BUILDING COMPLETION REPORT

NOTICE OF COMPLETION UNDER SECTION 187 (I) OF THE
CITY OF KARACHI MUNICIPAL ACT, 1933

FINAL.
PLAN SHOWING PROPOSED
ADD: & ALTERATION IN BUNGALOW
ON PLOT NO 173 J.M.I.
JAMSHED QUARTER.
SCALE = 8"=1'

With reference to your application dated 24-7-39,
with a plan for the proposed buildings/additions and alterations on plot
No. 64 Survey Sheet No. J.M.1, Jamshed Quarter,
I have to request you to comply with the following requirements—

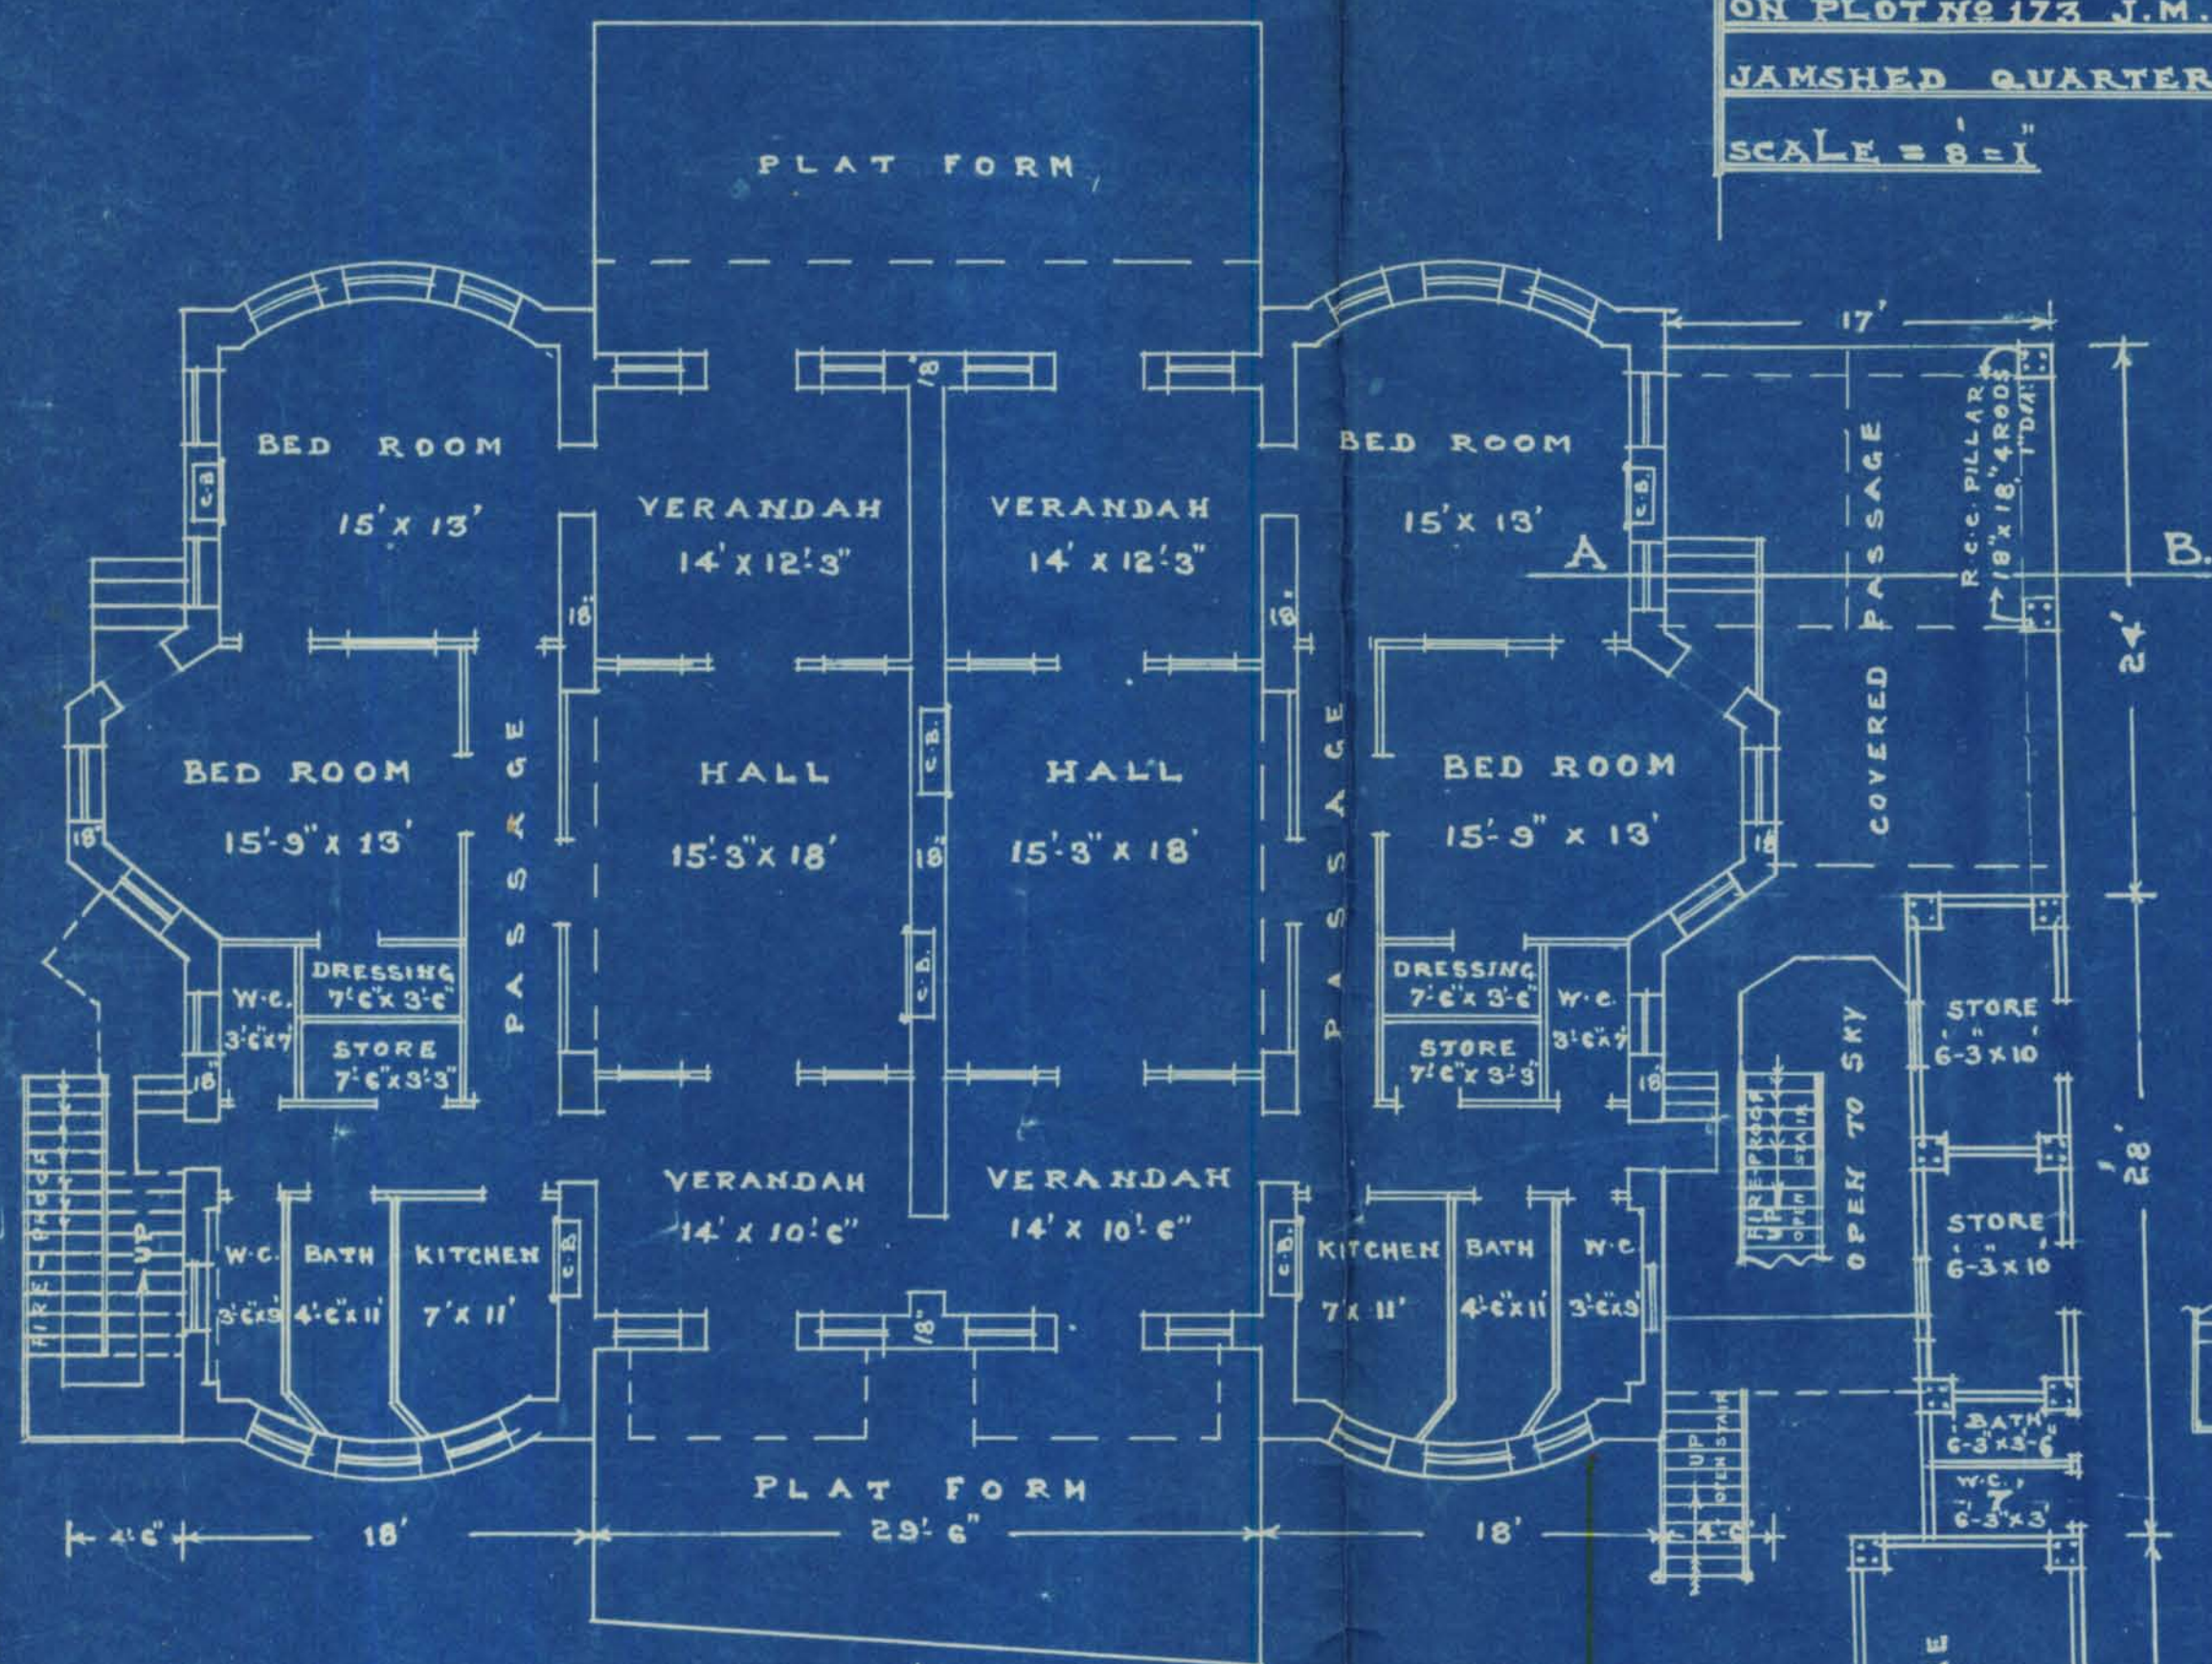
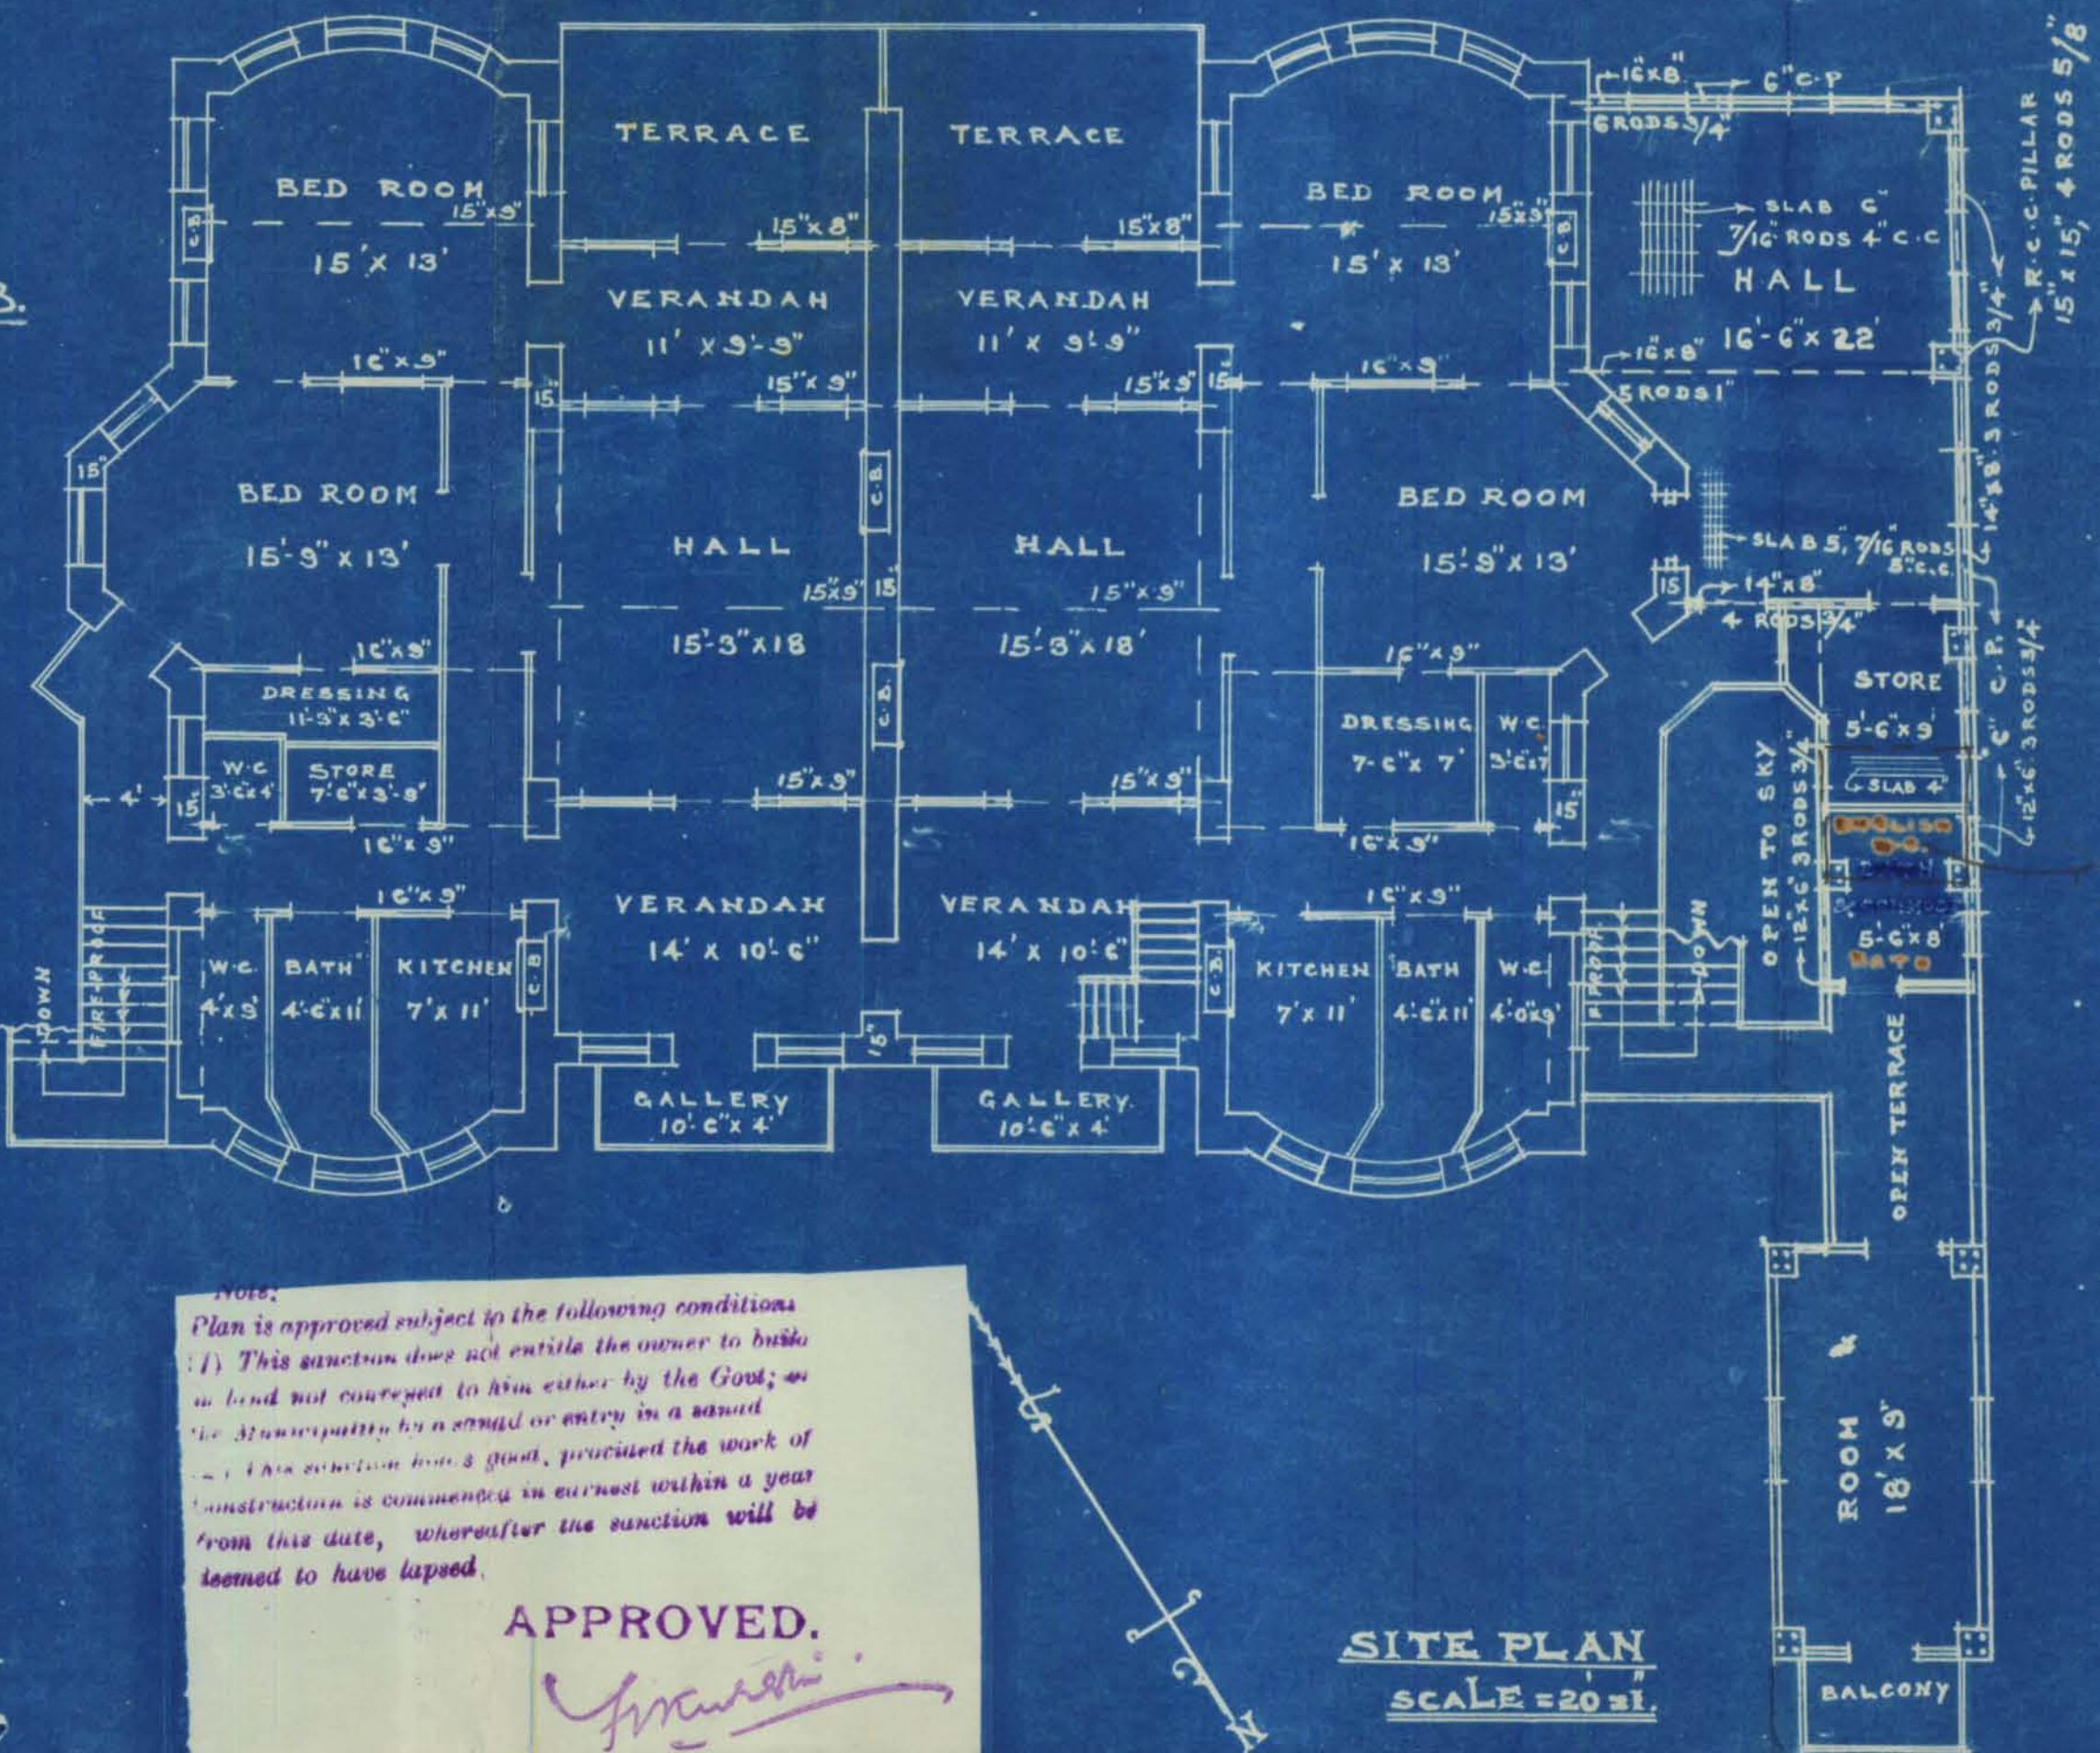
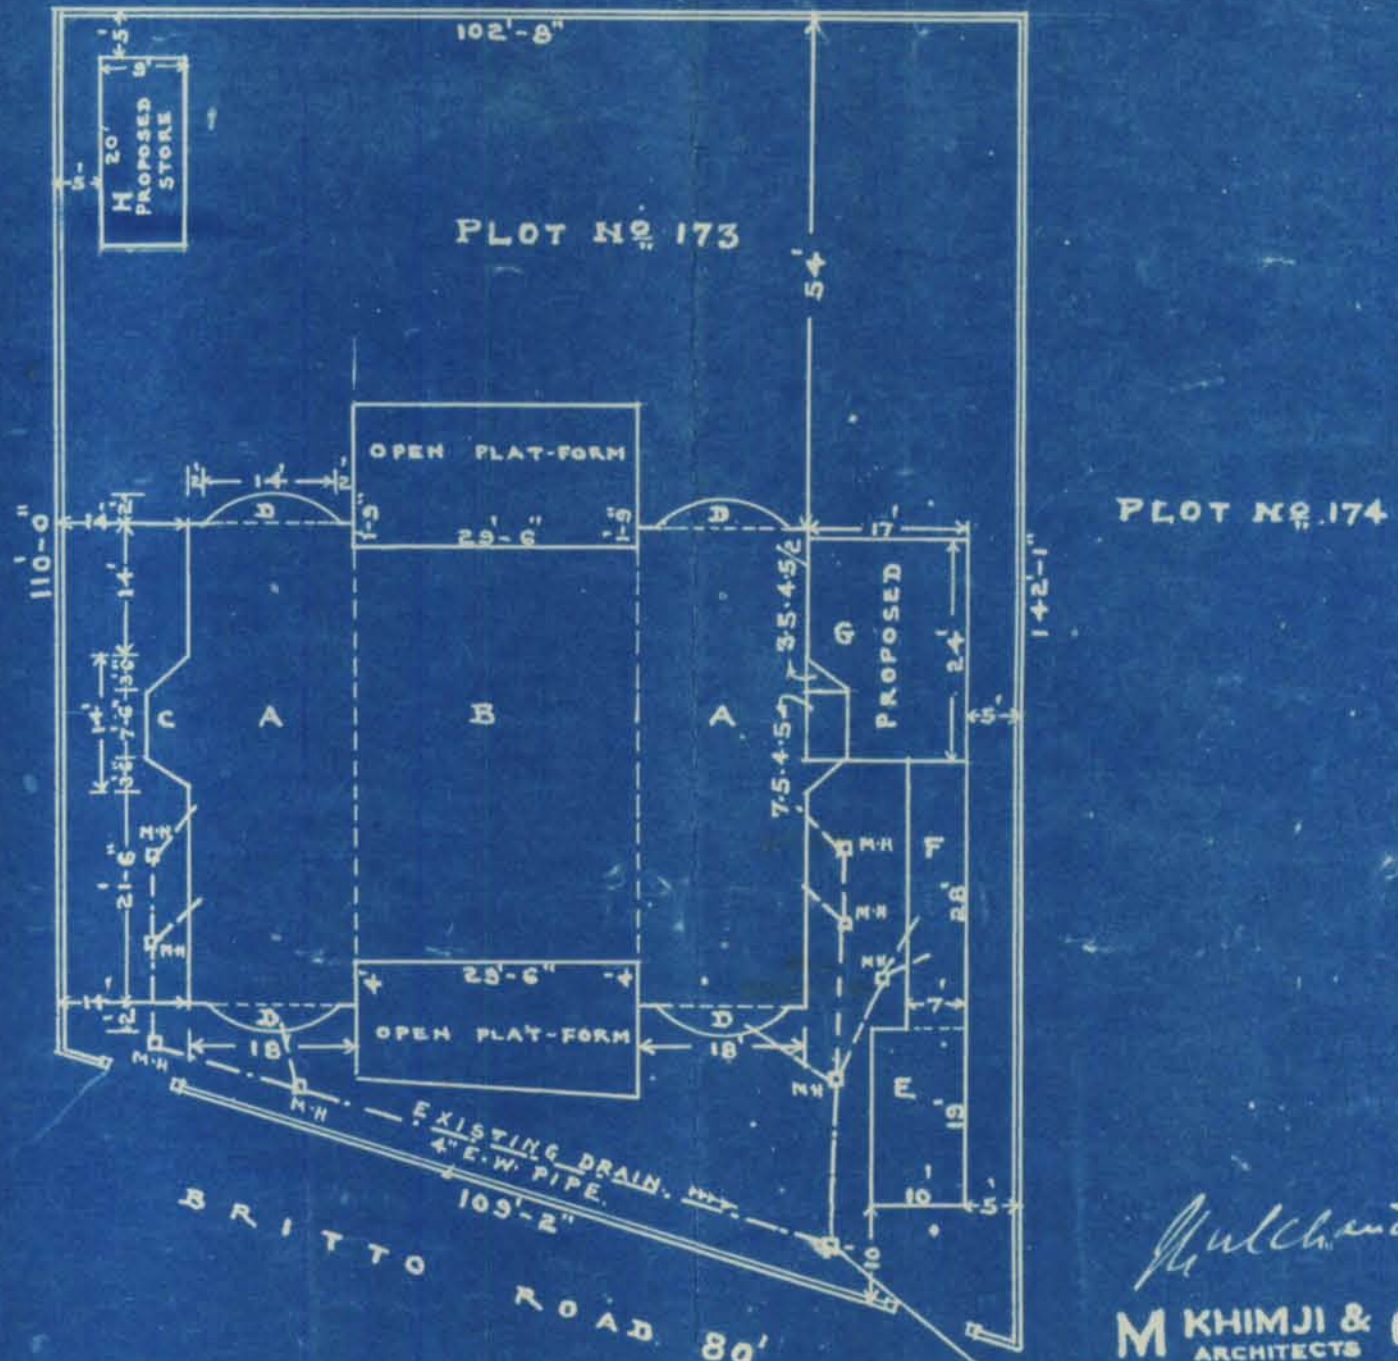
In reply to your letter No. ICP
480/38 dated 21st instant in connection
with plot No. 64 sheet J.M. I we beg to
return the plan after showing bath &
english w.c for favour of approval.
